RE: 55 Constitution Boulevard

Notice of Intent MassDEP File Number: 159-1301

MassDEP Review Comments

Infiltration System 1

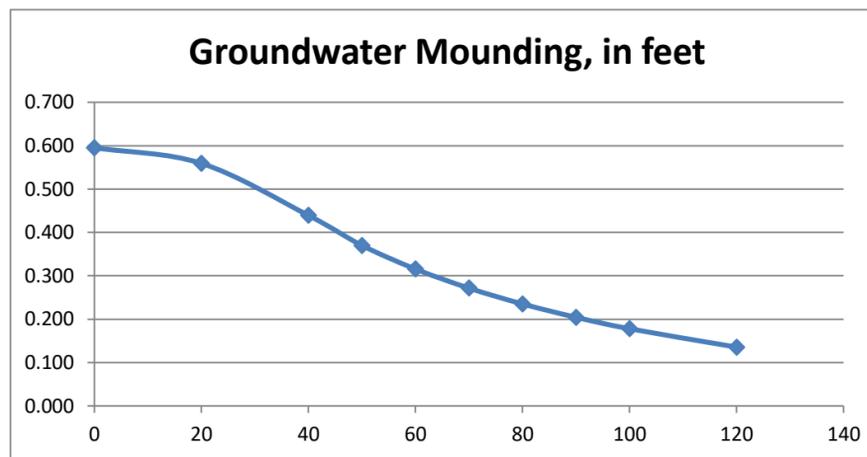
The Applicant proposes two subsurface infiltration basins. Test pit data was not provided for the location of the larger subsurface infiltration system. Test pit data is required at the location of any infiltration BMP, one sample for every 5,000 sf of basin to verify seasonal high groundwater and soil type. The Applicant should provide recent test pit information and confirm the depth is at least 2 ft to SHGW and/or bedrock at all areas of proposed infiltration. If less than 4 ft to SHGW, a mounding analysis is required. A detail on the separation from SHGW should also be provided. See V2, Ch2, p88 of the MA Stormwater Handbook. Has a mounding analysis been conducted for Subsurface infiltration basin #1 as SHGW is shown to be within 4ft to the bottom of the structure?

The project only proposes a single infiltration system. It is believed that the reviewer may have thought the system closest to the building was also an infiltration system, but it is designed as a detention system only with no provision for infiltration. For the single infiltration system, two test pits have been performed for the 2,800 +/- sf system. The bottom of the system is at elevation 338.30 and the ESHGWT is at 336.30. A mounding analysis has been performed for Infiltration System #1 and is shown in Attachment B of this response letter.

100.595	h(max)	maximum thickness of saturated zone (beneath center of basin at end of infiltration period)
0.595	Δh(max)	maximum groundwater mounding (beneath center of basin at end of infiltration period)
